# 1968 Corvette: Service Bulletin: Cracking of the Plenum at the Right Hood Latch Plate

**Bulletin No:** 68-T-68

**Date:** Nov. 11, 1968

**RIGHT HOOD LATCH REINFORCEMENT PLATE INSTALLATION**  
**1968 CORVETTE**

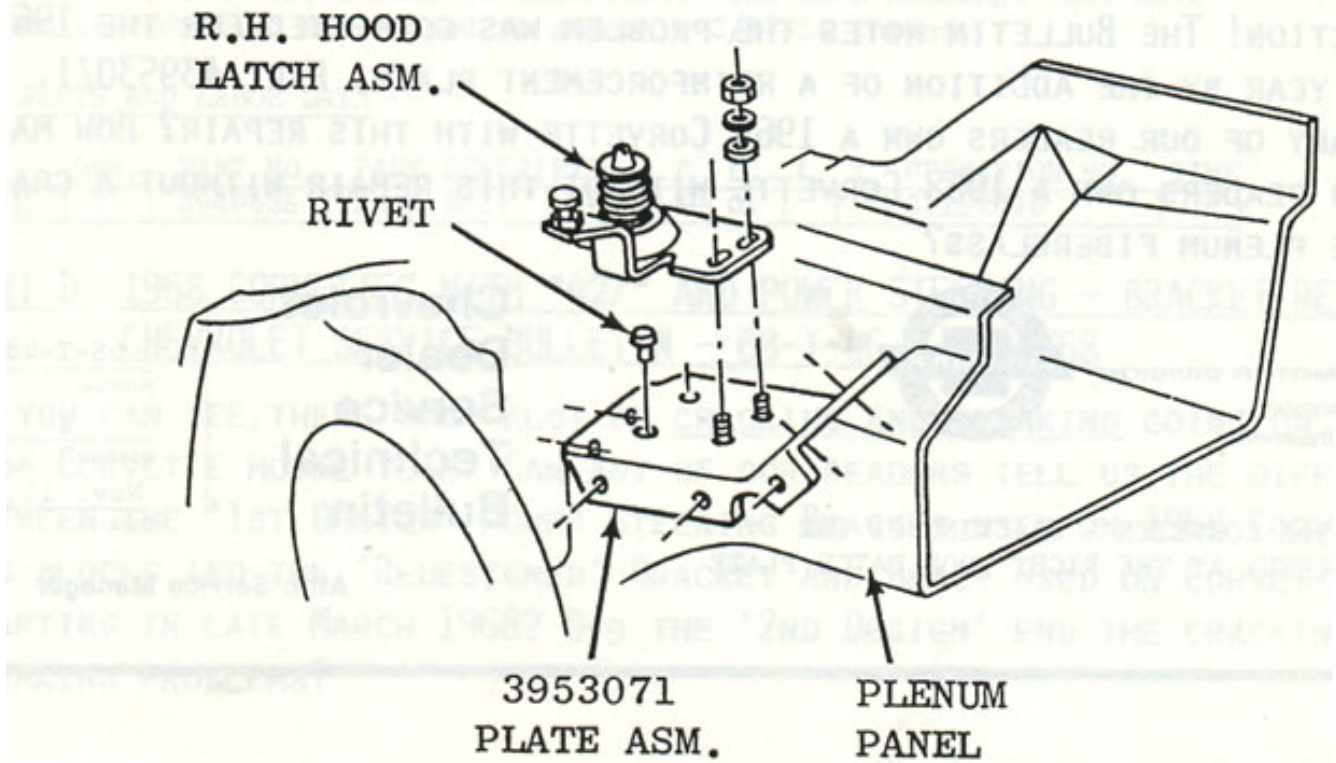
Cracking of the fiber glass plenum in the area of the right hood latch may be experienced on some 1968 Corvettes. This cracking is due to the manufacturing process of the plenum causing a glass rich condition in this area. This condition was corrected at the start of the 1969 production by the addition of a reinforcement plate to the area.

Whenever this cracking condition is encountered in the field, it may be corrected by riveting a reinforcement plate Part No. 3953071 to the outer surface of the plenum as outlined under Service Procedure.

1. Remove right hood latch assembly from the plenum panel and remove cowl vent grille.
2. Drill out two rivets retaining existing stud plate to plenum using a 7/32" dia. drill bit. Remove stud plate through cowl vent opening.
3. Position reinforcement plate on plenum as shown in sketch and drill seven (7) holes 7/32" dia. at hole locations in plate. The two (2) outboard holes are not accessible for drilling.
4. Attach the reinforcement plate to the plenum using 3/16" x 5/8" "Pop" Rivets.
5. Install and adjust right hood latch assembly as outlined in the August 1968 issue of "Chevrolet Service News." Install cowl vent grille.
